## Merrylands Town Centre Public Domain Plan Feedback

Thank you for the opportunity to comment on the Merrylands Town Centre Public Domain Plan (The Plan).

Marked up map from Open Street Map (Cycle Map Layer<sup>[1]</sup>) showing Active Transport links around Merrylands.

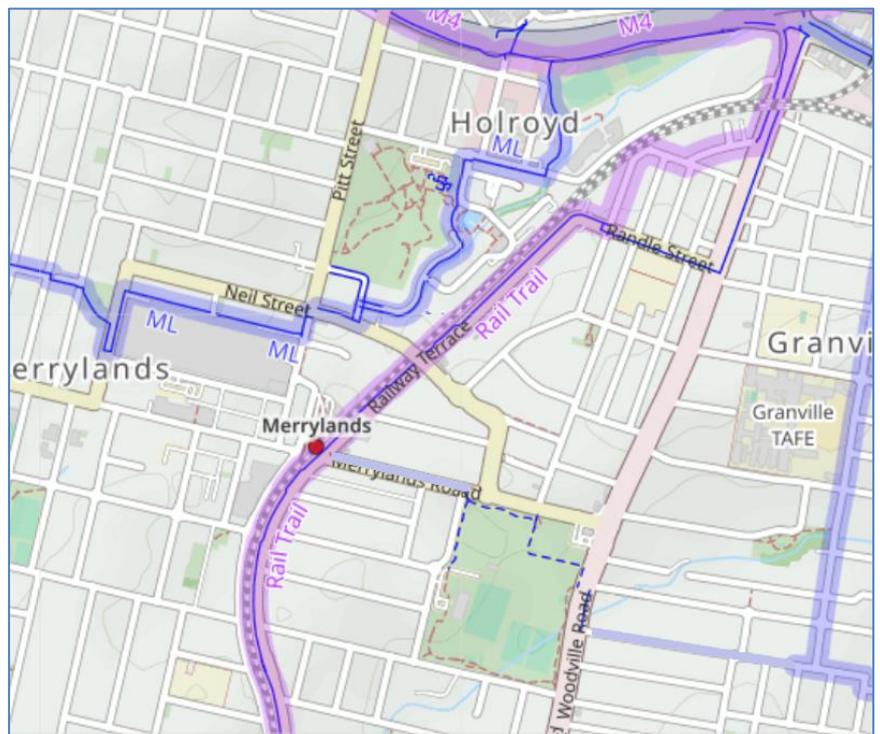
As can be seen on the map, the existing paths around Merrylands consist of the Parramatta to Glenfield Rail-Trail shared path along the eastern side of the railway line, the A'Becketts Ck path up to the rear entrance of Holroyd Gardens and the M4 path, a not particularly direct link from Merrylands Park that hugs the northern border of the town precinct on the western side of the line, and a combined on/off-road route on the eastern side of the line using Merrylands Rd (East) roadway, a path through Granville Park, a crossing of Woodville Rd at Louis St, then a path down Woodville Rd to Meadows St where riders use on-road facilities into Granville and further east. The Merrylands to Granville corridor is one of the key strategic corridors identified in the Central River City overview document<sup>[2]</sup>.

With this latter route we believe there are both safety improvements that can be made with the current route but also possible alternative routes between Railway Terrace and Granville Park that would avoid Merrylands Rd and be more appealing to less confident on-road riders. These are largely outside the main precincts of The Plan and won't be pursued further here, but we're happy to provide further input on request.

*Marked-up map from Open Street Map (Cycle Map Layer<sup>[1]</sup>) showing the current shared path either side of Treves St and proposed path.*

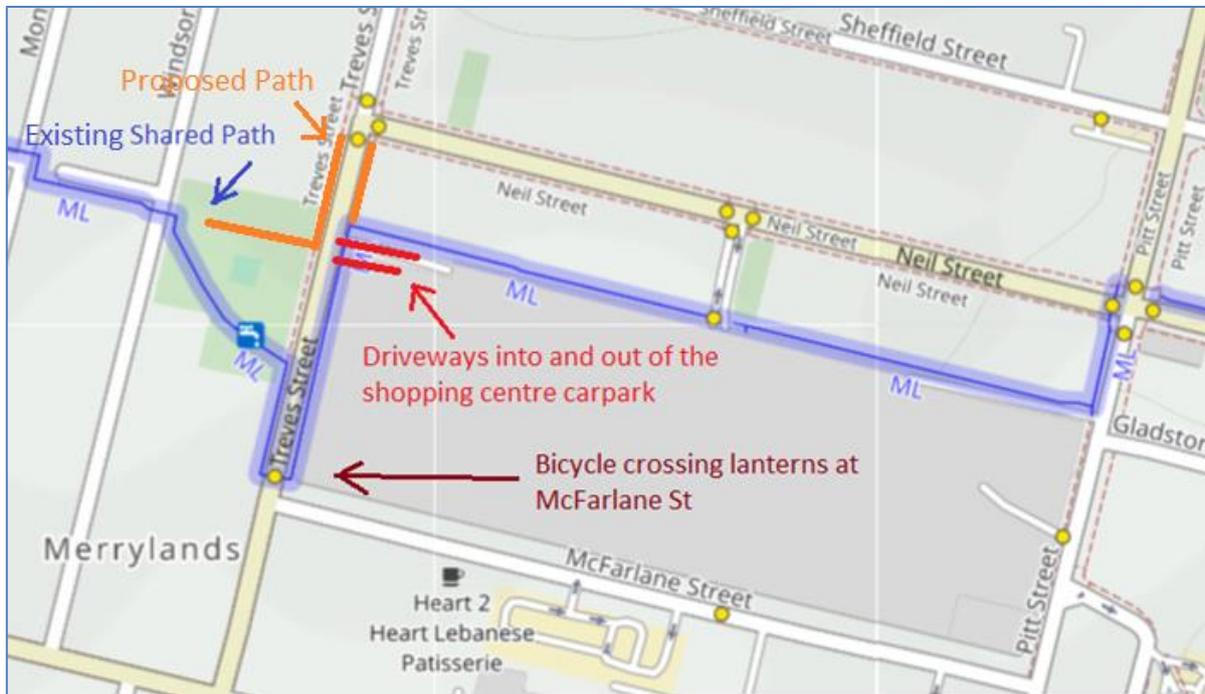
Bordering on the Town Centre Precinct area, we believe access to the route from Merrylands Park through Merrylands Memorial Park could be improved. This route likely forms part of the Merrylands to Greystanes key strategic corridor<sup>[2]</sup>. The current route has riders traversing both sides of Treves St to the bicycle crossing lanterns at McFarlane St and takes riders across one of the busy parking entrances/exits for Stockland Shopping Centre. We would've thought a safer and more direct option would've been to create a straighter route through Memorial Park and ideally create a new crossing of Treves St or maybe more practically take the shared path to Neil St to cross. This route appears to cross only 1 significant driveway, while avoiding the shopping centre carpark entrance and exit.

Figure 10: Neil Street Plan

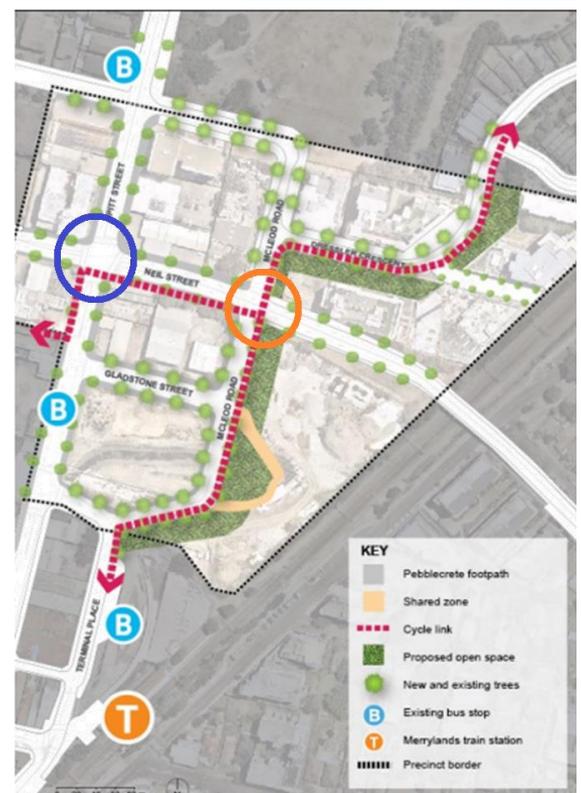
*The following three items refer to marked-up image of Figure 10 from The Plan to the right:*

- Are we correct in assuming that the proposed cycle link crossing of Neil St at McCleod Rd (circled in orange) will be signalised? We believe the crossing could potentially be quite dangerous if not.
- There is no 'Cycle Link' shown on the northern side of Neil St between McCleod Rd and Pitt St. The recently completed path along this section is not currently marked as a shared path, although it appears wide enough to be considered one. Note that a proposed cycle path is shown on the southern side of Neil St.
- The signalised intersection of Pitt and Neil Streets (circled in blue) currently only have bicycle lanterns for the two crossings starting from the south-west corner of this intersection. The other two crossings (which join the path in the above point) currently have pedestrian-only lanterns.

Figure 8: McFarlane Street Precinct (Merrylands Station)

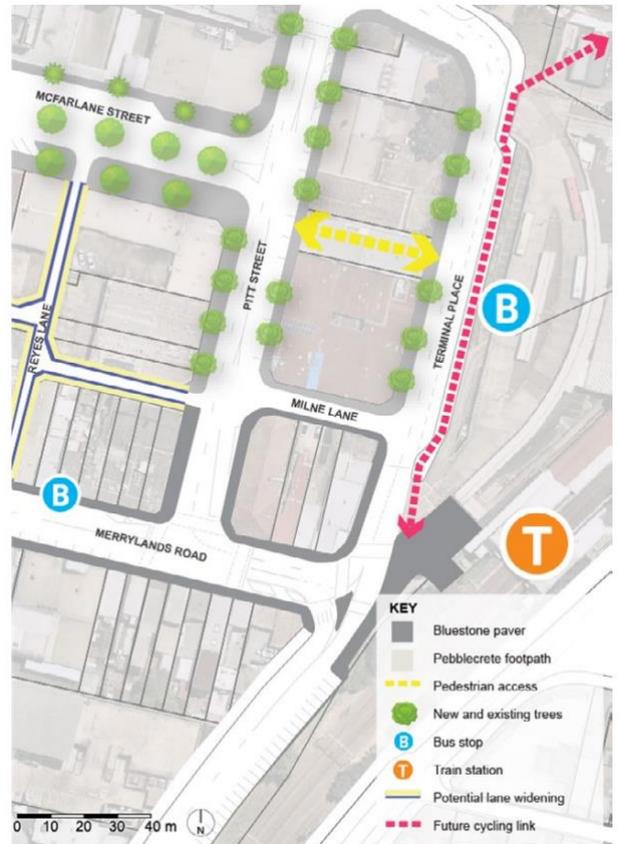
- The Future Cycling Link along Terminal Place shown in The Plan's Figure 8 is alongside an existing Taxi Rank and Bus Stop. There is currently scope for conflict between different path users. Are there are plans to re-design this area?

- It's not clear to us from The Plan how bike riders should move through the McFarlane St precinct East-West. While the path through Memorial Park may be a suitable town-centre bypass particularly for users from the west or north-west segments of Merrylands, it doesn't readily serve those from the south-west or those wanting to directly access the main shopping precinct. We'd ideally like to see some separated on-road cycling lanes. However, if on-road along McFarlane Rd and/or Merrylands Rd is not feasible, we believe that the speed limits should be further reduced to 30kmph around the precinct and the coverage area extended beyond the current 40kmph zones.
